## TRANSMITTAL OF MEETING HANDOUT MATERIALS FOR IMMEDIATE PLACEMENT IN THE PUBLIC DOMAIN

To meet with Westinghouse to discuss construction

## INCONSISTENCIES NOTED WITH AP-600 DOCUMENTS

SFP Drawing:

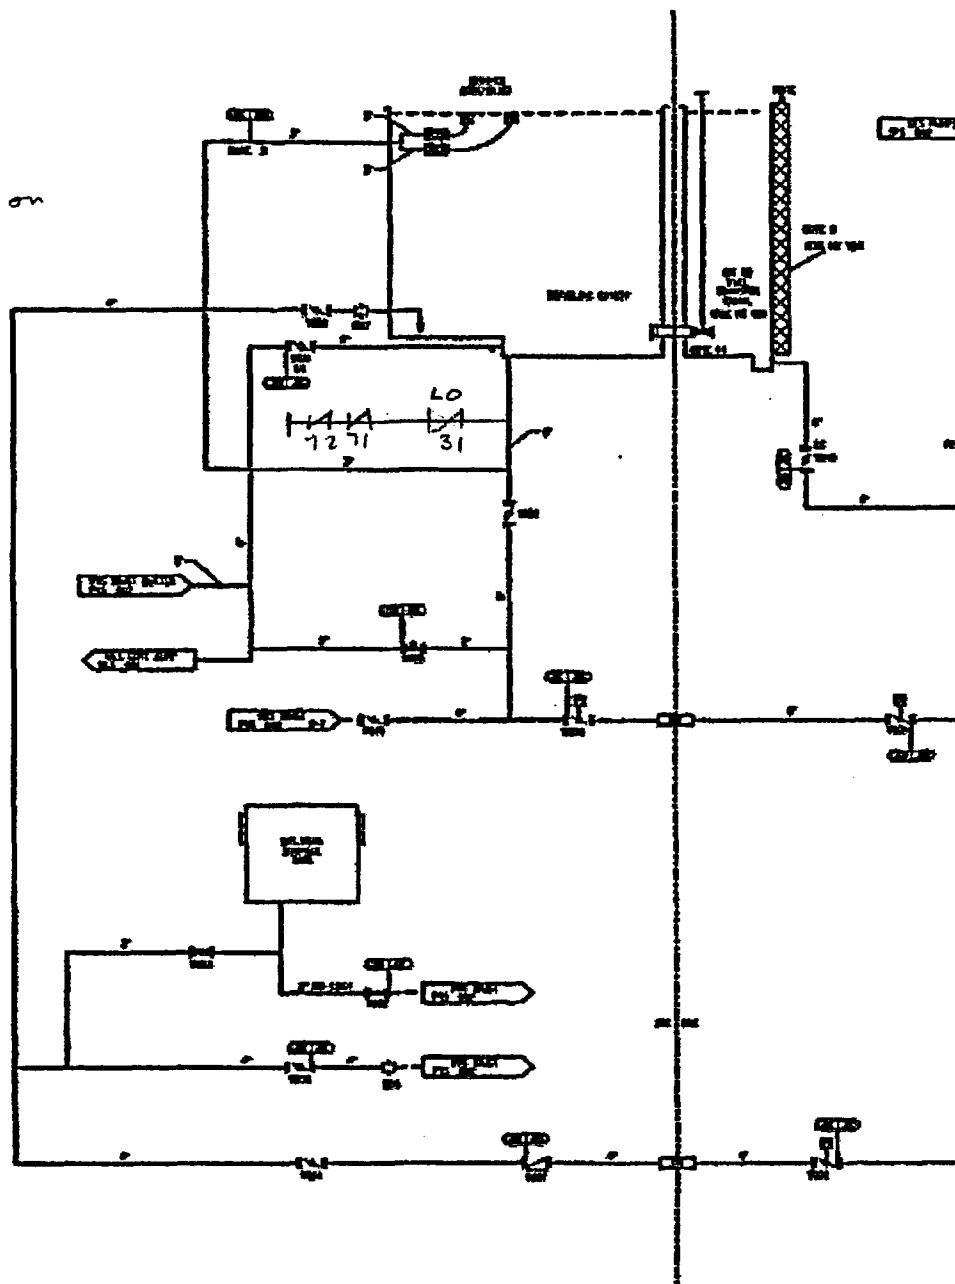
4. Tier 1 Figure 2.3.7-1, SFP Cooling, specifies that a number of pipe segments are classified ASME Section III but there is no listing of ASME components in Table 2.3.7-1. Most of the other sections list the system valves that provide the Code break change. (The drawing in the Tier 2 document does not include line numbers or Code break flags.) Shouldn't the valves be included in the Table?

5. Tier 1 Table 2.3.7-1 lists Line L030 as the Reactor Cavity Drain line but it appears that the line should be labeled Refueling Cavity Drain Line. The same condition exists in the AP-1000 Tier 1 DCD which has two lines (L030 & L040) listed Reactor Cavity Drain lines. The piping shown on the P&ID for both plants are connected to the refueling cavity. A new Section 9.1.3.3.8 was added to the AP-1000 SFS System Description that discusses a line from the Reactor Cavity to the Steam Generator Compartment but this is apparently a different line not shown on the P&ID. A new line with a LO manual valve and two check valves as discussed in 9.1.3.3.8 is shown on AP-1000 Figure 9.1-6 connected to the refueling cavity but its opposite end appears to be blank flanged. (The Reactor Cavity Volume for these designs is somewhat different than earlier designs and is shown on Figures 19.39-5 & 6.)

Line shown on  
AP-1000  
Fig 9.1-6
